RUSSIAN FEDERATION
MINISTRY OF TRANSPORT OF RUSSIAN FEDERATION
FEDERAL AIR TRANSPORT AGENCY
AIRWORTHINESS DIRECTIVE

No. 2021-AHCAT, AHCAT-K-04

Applicability – ANSAT, ANSAT-K helicopters (model ANSAT-K) and their modifications

TECHNICAL DECISION No. 1/144-2021-KB3
on continued airworthiness of ANSAT, ANSAT-K (ANSAT-K model) helicopters and their
modifications in connection with failure of the bearing 6-3056204 ETY100/3 of tail rotor
sliding bar
Revision 2

Figure 1

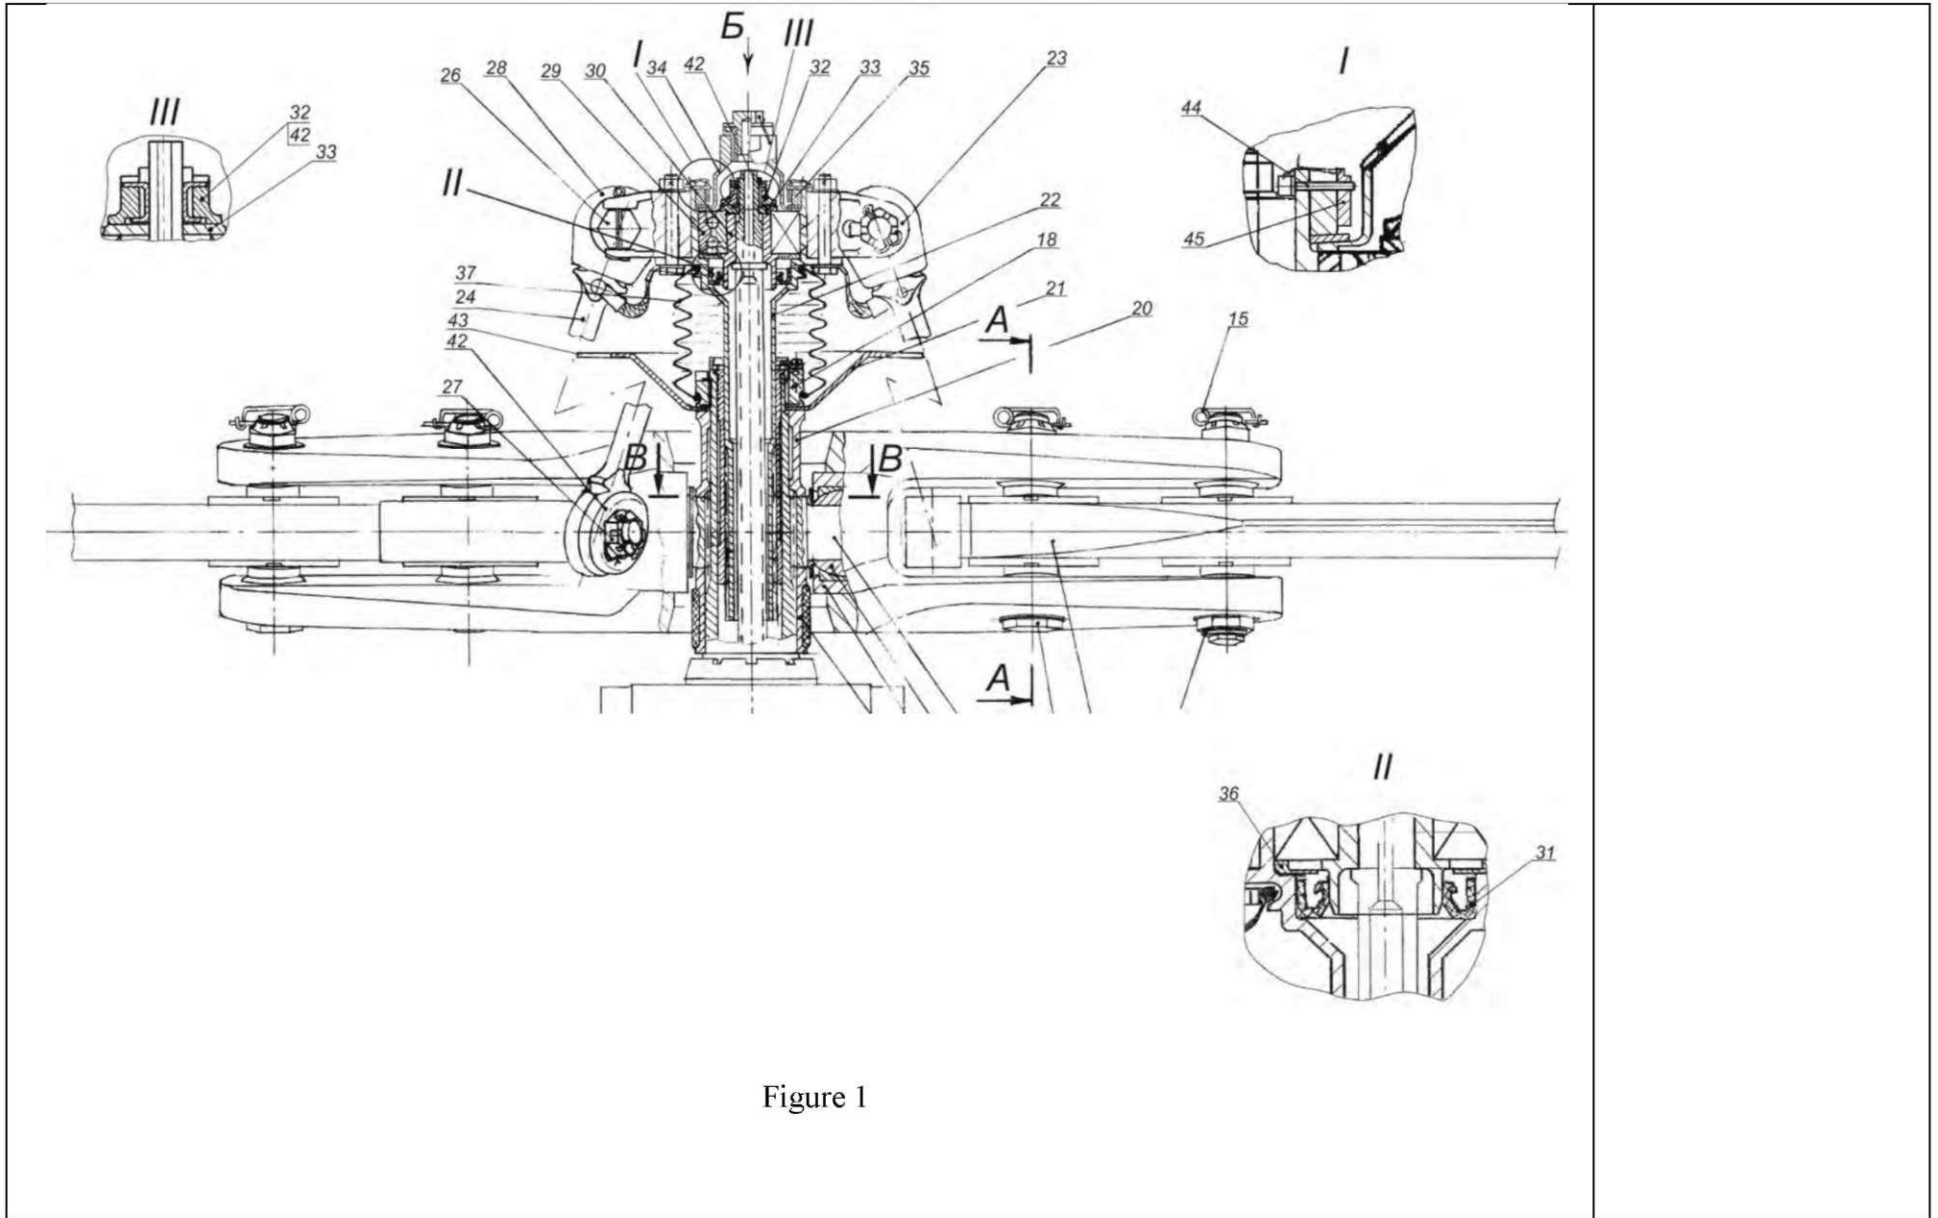
Temporary task card 064.20.00 м	
Procedure: Inspection of tail rotor elements	
Operations and technical requirements	Corrective actions
<ol style="list-style-type: none"> 1. Remove sliding bar from tail gearbox shaft: <ol style="list-style-type: none"> 1.1 Place a step-ladder near the tail gearbox. 1.2 Connect a ground hydraulic unit to the helicopter hydraulic system. Switch on the power supply. Set the sliding bar to a maximum extended position, having fully pressed the left pedal in the pilot's cabin as far as it can go. 1.3 Unlock and undo the nuts from the bolts attaching tie-rods to the rocker, remove the bolts. Disconnect tie-rods from the rocker. 1.4 Unlock and undo the nuts of the blades scissors pins. Remove washers of hubs and tie-rods from the pins. 1.5 Unlock the nut retaining the outer ring of the sliding bar bearing. 1.6 Install fixture 333.9950.000 (НАЛФ.333.9950.000) on the rocker and undo the nut. Remove the washer and cover installed in the sliding bar. 1.7 Unlock the rod nut, having unbent lobes of the flap locks. Undo the nut. Remove the stop washer from the rod.. 1.8 Having moved the sliding bar with a rocker towards the tail rotor, remove the bearing from the sliding bar. Remove the bearing and the bushing, installed under the bearing, from the rod. 2. Check the bearing (pos. 29, fig. 1 of this card) with the bushing (pos. 30) installed in it for absence of seizing, jamming, non-smooth running, extraneous noise. In case of detection of these defects, the bearing and bushing shall be replaced. 3. Remove bushing (pos. 30) from inner ring of the bearing (pos. 29). If it is impossible to remove the bushing by hand force - the bushing and the bearing must be replaced. <p>CAUTION: THE BUSHING MUST BE REMOVED FROM THE BEARING WITHOUT TENSION, BY HAND FORCE. THERE SHOULD BE NO MECHANICAL DAMAGES ON THE BEARING (INCLUDING VISIBLE PARTS OF THE SEPARATOR) (SCRATCHES, NICKS). THE BEARING SHOULD ROTATE SMOOTHLY, WITHOUT JAMMING.</p> <ol style="list-style-type: none"> 4. Install the sliding bar on the tail gearbox shaft:

4.5 Slide the sliding bar from the tail rotor, having put the sliding bar bearing, secured on the rod, into the sliding bar.

4.6 Install the cover and washer. Return the nut into the sliding bar and tighten it with 60...70 N•m (6.0...7.0 kgf•m) torque using fixture 333.9950.000 (НАЛФ.333.9950.000) preinstalled on the rocker. When tightening the nuts, align the nut slots with holes in the sliding bar.

4.7 Lock the nut using two locking screws, installed in the holes of the sliding bar, aligned with the grooves of the nut (pos. 35) and screw them into the nuts (pos. 45). Lock the screws with locking wire 0.8mm in diameter wire.

List of parts and assemblies of tail rotor hub

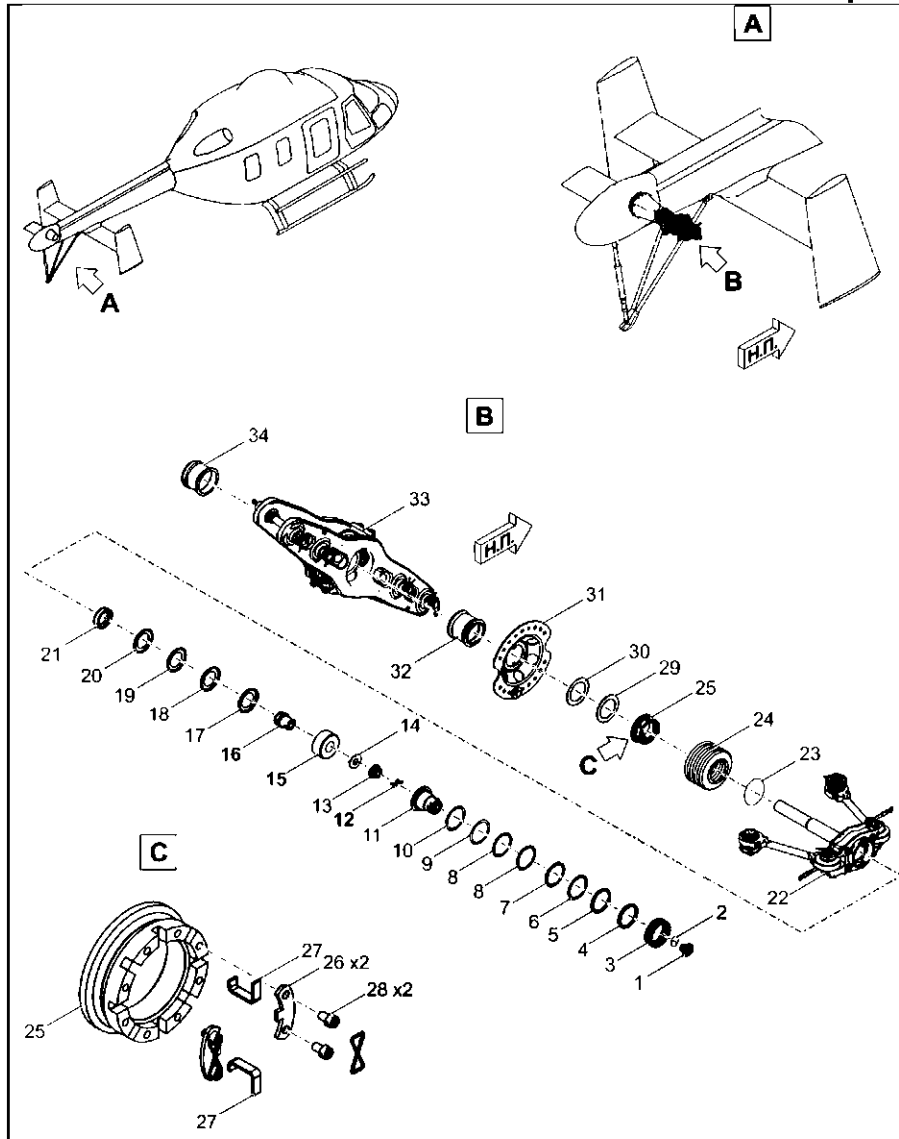
At that make an entry in column “Remarks” in section 2 “Delivery set” of certificate 333.3520.1000-ПЦ of the number of actually installed washer 333.3500.0033- and 333.3500.0037- (see Annex 5), having measured their thicknesses beforehand.
